Product/process change notification

PCN N° 2022-079-A

Introduction of an additional assembly location at HANA Semiconductor (Ayutthaya) Co., Ltd. for products in PG-DSO-16

■ ATX

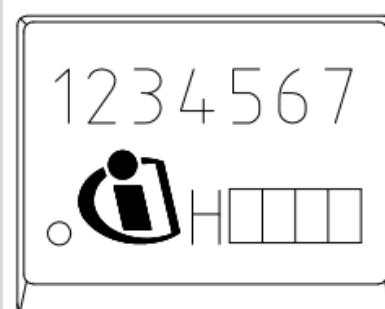
Assembly Site Code Marking
